**SEQUOYAH FUELS CORPORATION
RESPONSE TO REQUEST FOR
ADDITIONAL INFORMATION
GROUND WATER CORRECTIVE
ACTION PLAN REVIEW**

Subject: Sequoyah Fuels Corporation, Docket – 40-8027
Request for Additional Information – Groundwater Corrective
Action Plan (TAC L52528)

Responses to NRC RAIs of September 28, 2005
Ground Water CAP Review

FIGURE 2-14
POTENTIOMETRIC SURFACE SHALE 1
JUNE 2001

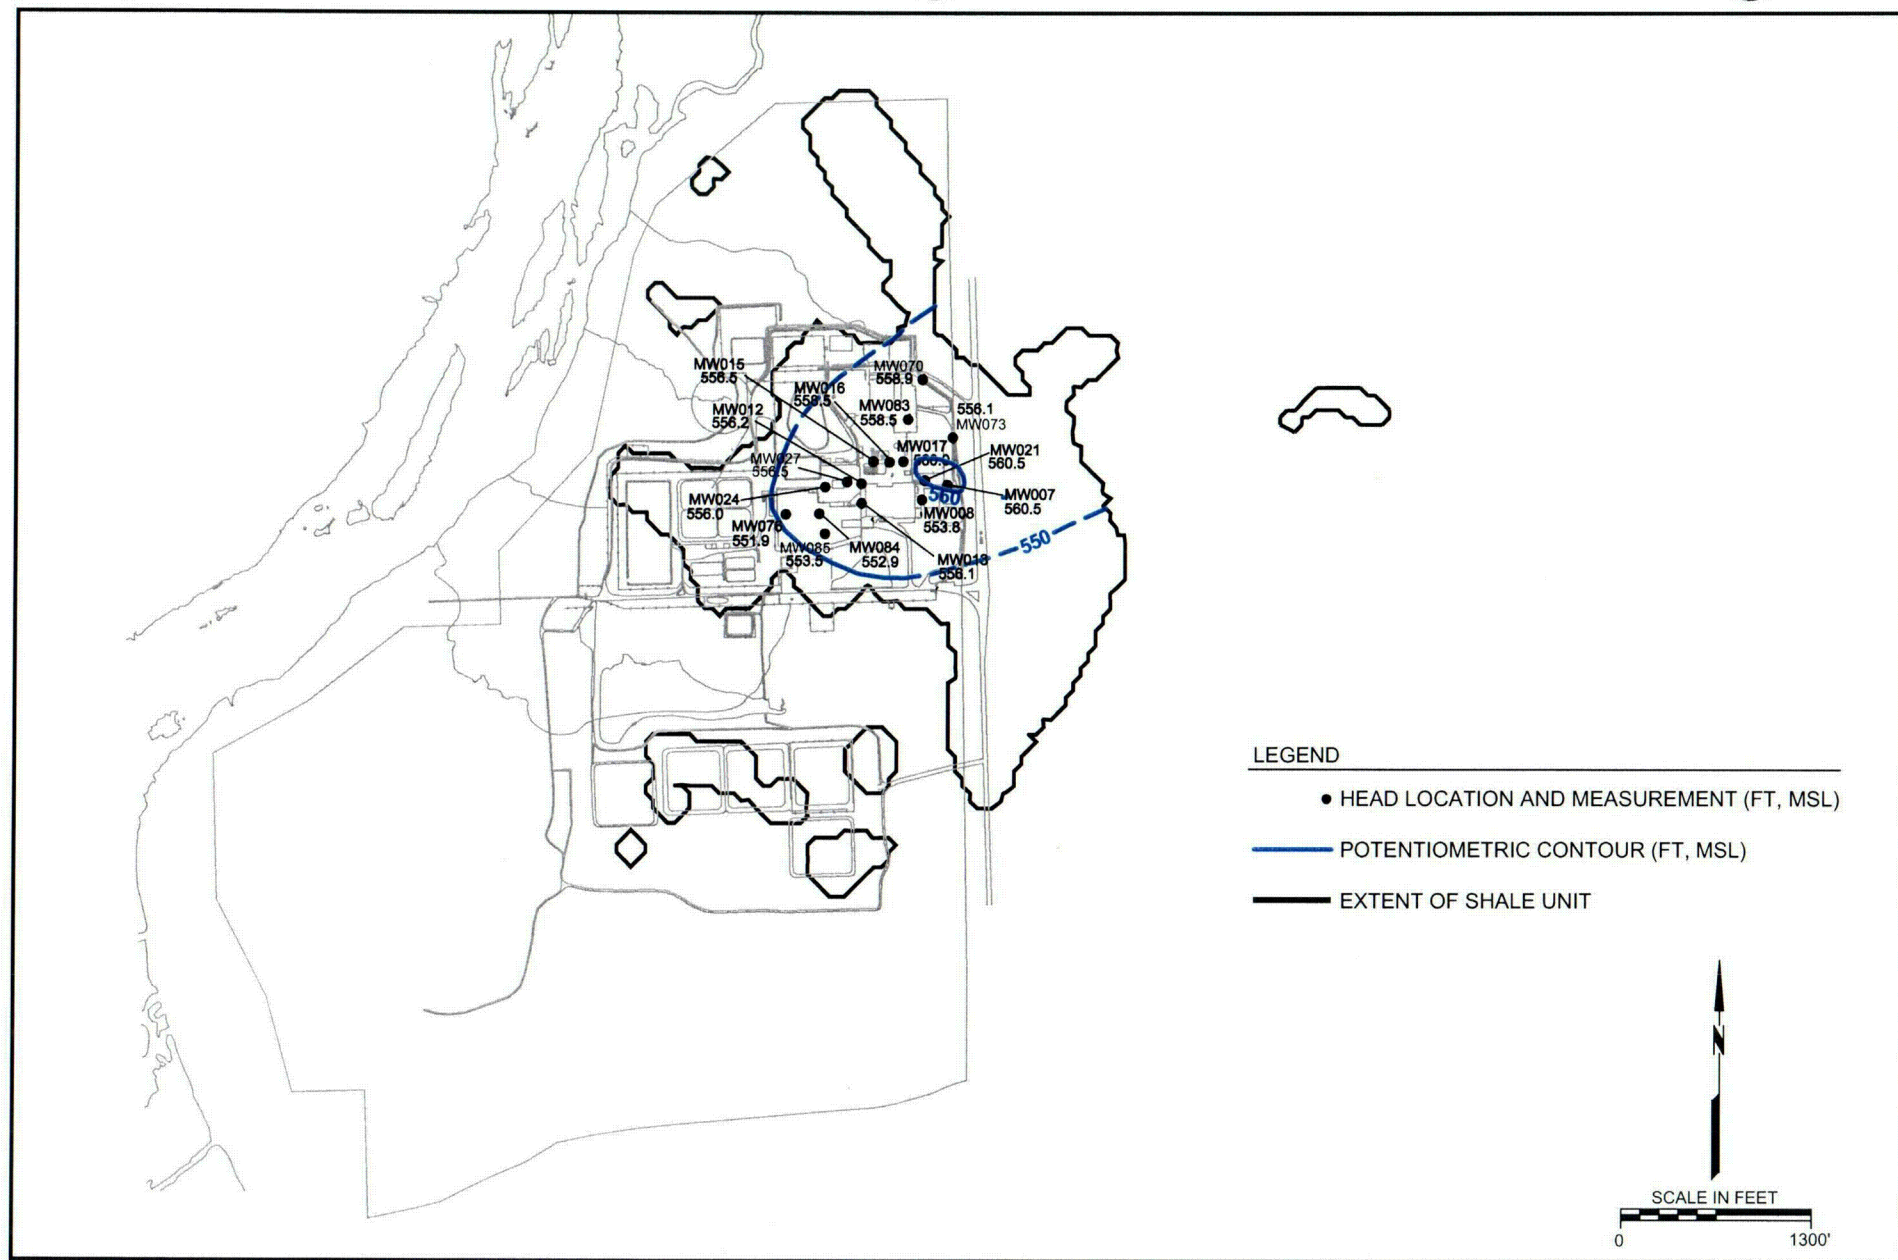
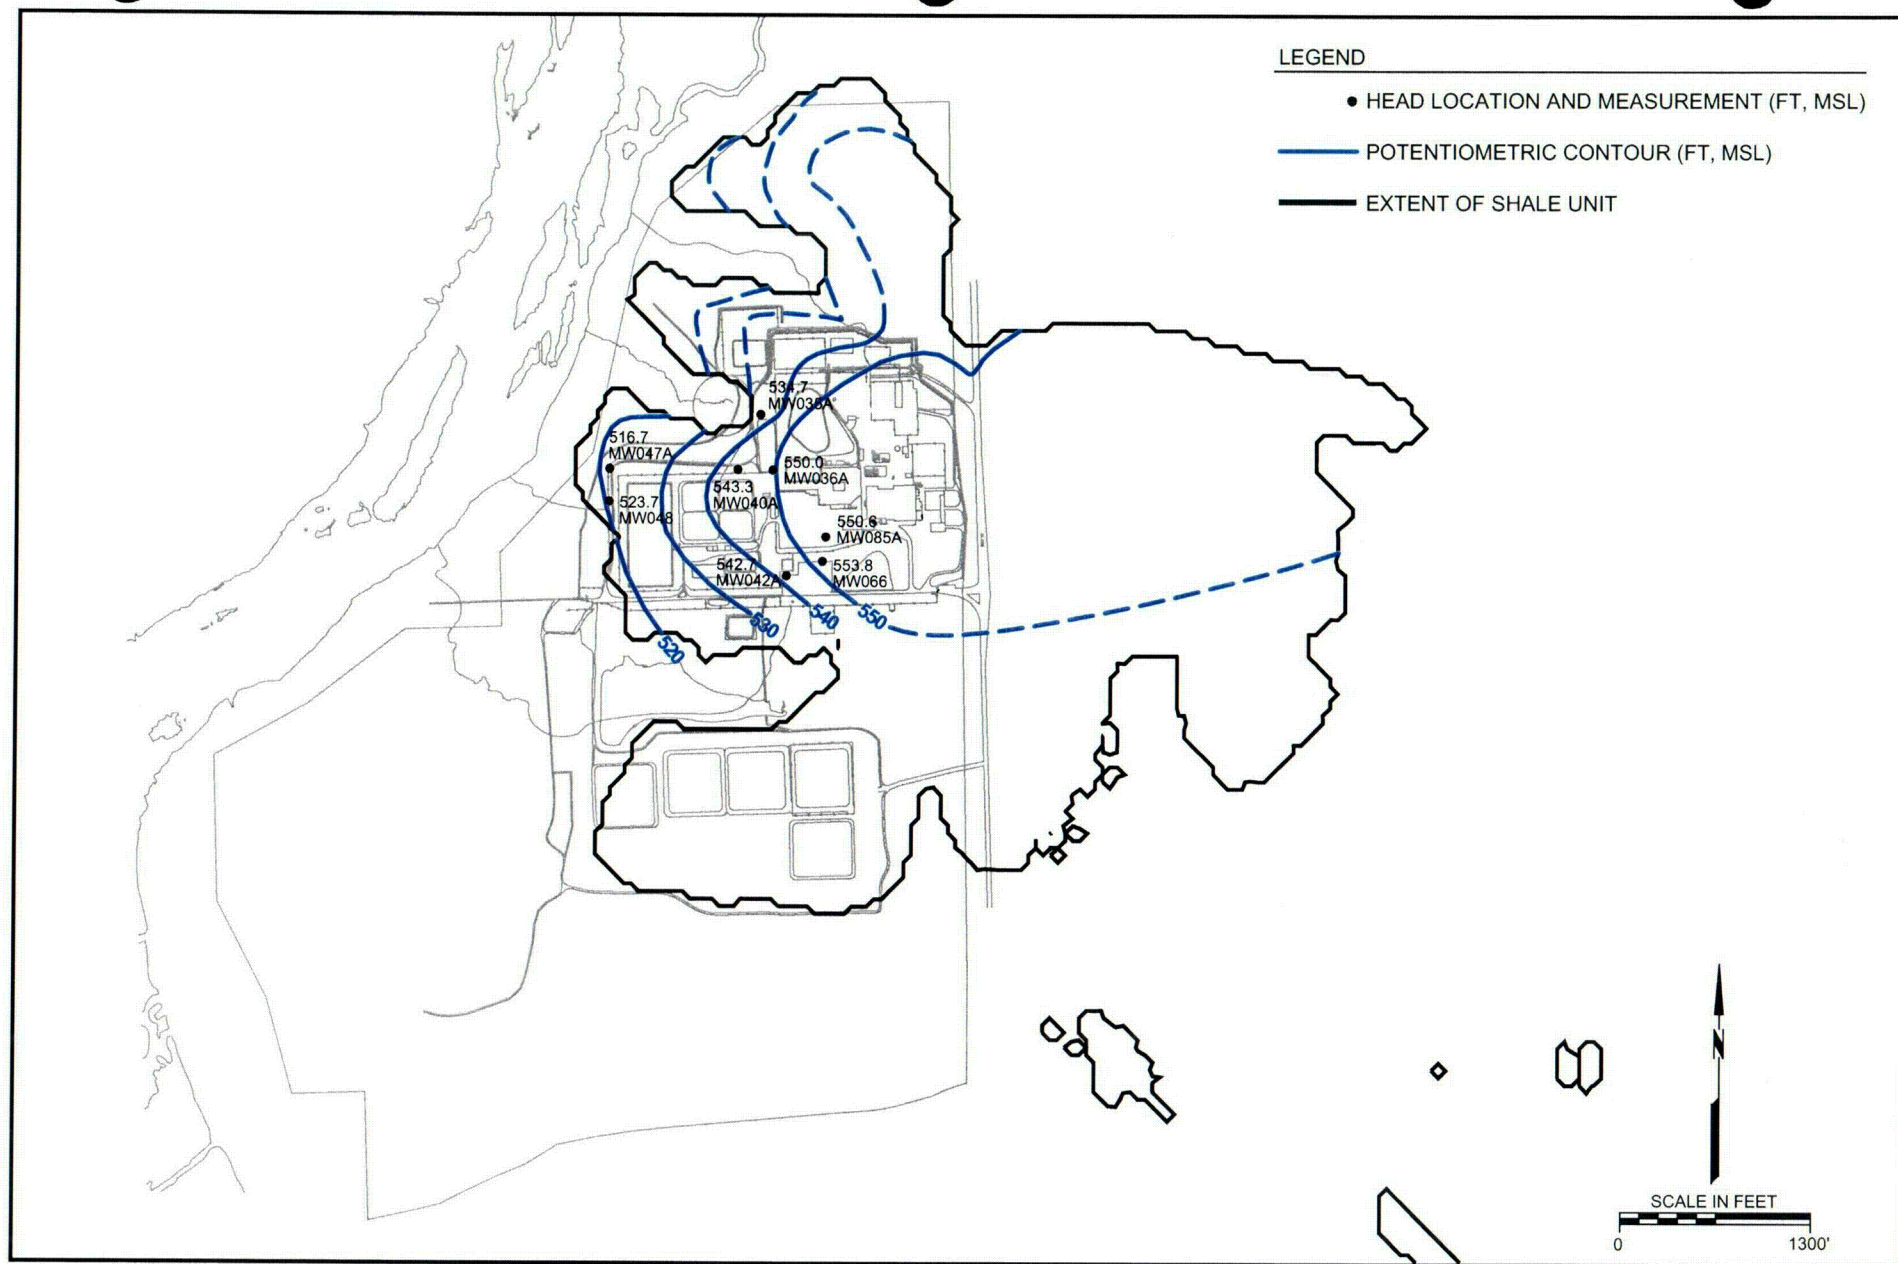
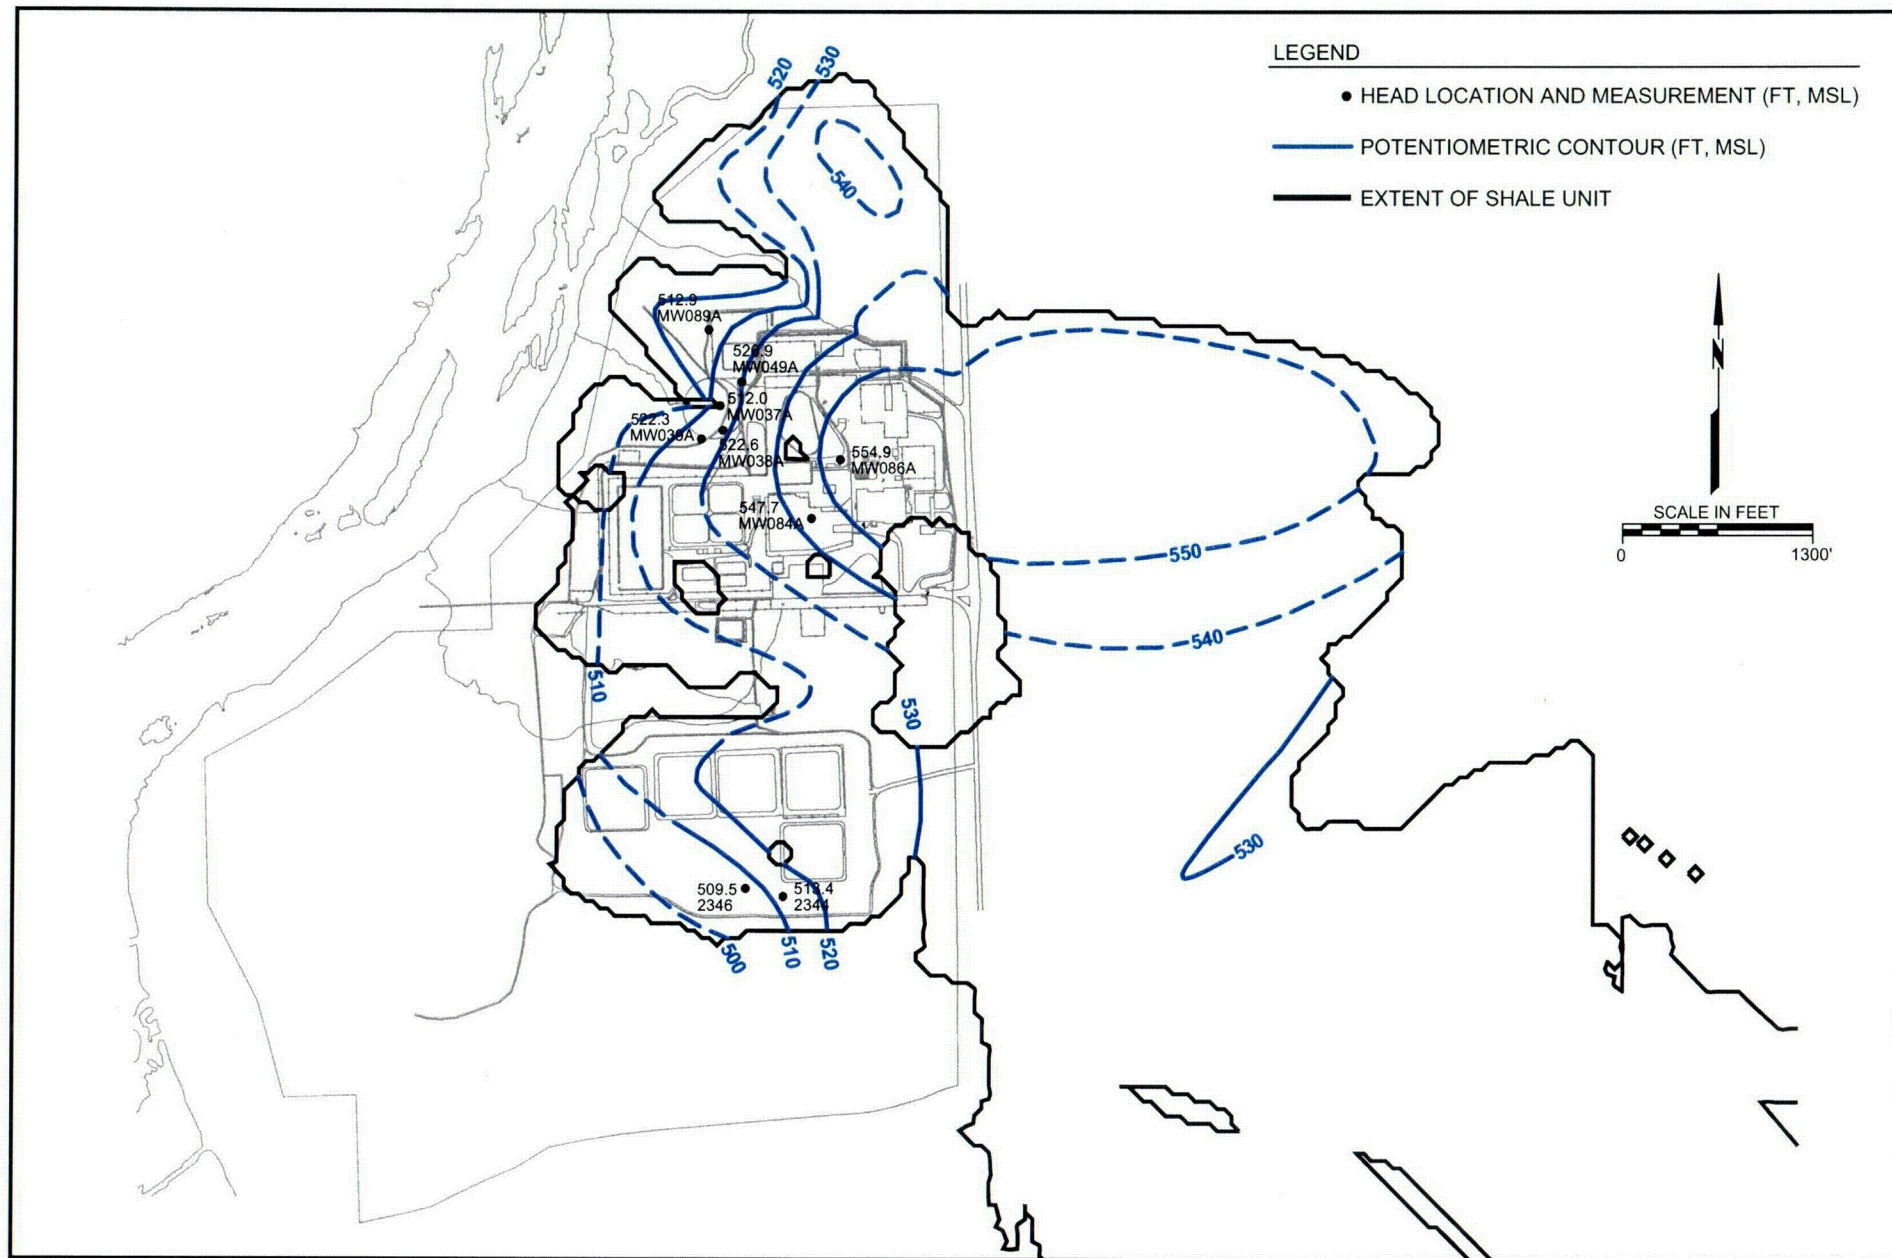
- B. Figures 2-8 through 2-13 contain geologic cross-sections; however, these also need to include the potentiometric surface of the uppermost aquifer and the locations and screen depths of ground-water monitoring wells used to measure the potentiometric surface. This information is necessary to examine the relationship between the potentiometric surface, site structures or features, and underlying geologic units. This information will allow NRC staff to evaluate whether extraction wells and trenches are placed in effective locations for capturing ground-water contamination.

- D. SFC should also present a discussion of the contouring method used to create potentiometric surface maps and should also present a contoured map of residuals. Discussions of the contouring method will allow NRC to evaluate the validity of the mapping procedure (not model validity). A residuals map will allow NRC staff to determine if data for certain areas of the site exhibits a high degree of uncertainty and whether such a condition would impact the selection of remedial alternatives.

CAP Figures 2-14 through 2-18 illustrate the measured potentiometric surface for the alluvium as well as Shale units 1, 2, 3, and 4 and the lateral extent of these units. Additional figures are attached to this response as Attachment CAP2B illustrating the modeled particle flow paths related to the corrective actions to illustrate the capture zones of each interception trench or recovery well. In addition, in response to Question CAP3B, a figure is included showing the entire industrial area with all site features, topography, remediation facilities (including corrective action trenches and dewatering wells), and color coded potentiometric lines for all saturated zones (Shale 1 through Shale 4). This figure is a composite of CAP Figures 2-14 through 2-18.

The hydraulic gradients for individual hydrostratigraphic units are identified graphically in CAP (2003) Figures 2-14 through 2-18 (Attachment CAP2C-3); the northings, eastings as well as measured and computed heads in specific wells are also provided in HGSCR (2002) in Table 8-3, which have been copied and included with these responses in Attachment CAP2C-4. From these figures and data, specific gradients of interest can be easily calculated.

The data used to develop the potentiometric contours are posted in Figures 2-14 through 2-18 (Attachment CAP2C-3). Due to limited data and boundary effects associated with computer contouring, these contours were generated by hand based on professional judgment by a qualified hydrogeologist. There are no residuals (difference between measured head and contoured head) to be mapped since the precise measured heads were used to generate the contours. The residuals for the calibrated flow and transport model are presented in Table 1 of the March 7, 2005 Technical Memorandum regarding revisions to the ground water model submitted to the NRC on March 14, 2005 as part of the first round of responses to RAI's on the Ground Water Corrective Action Plan.
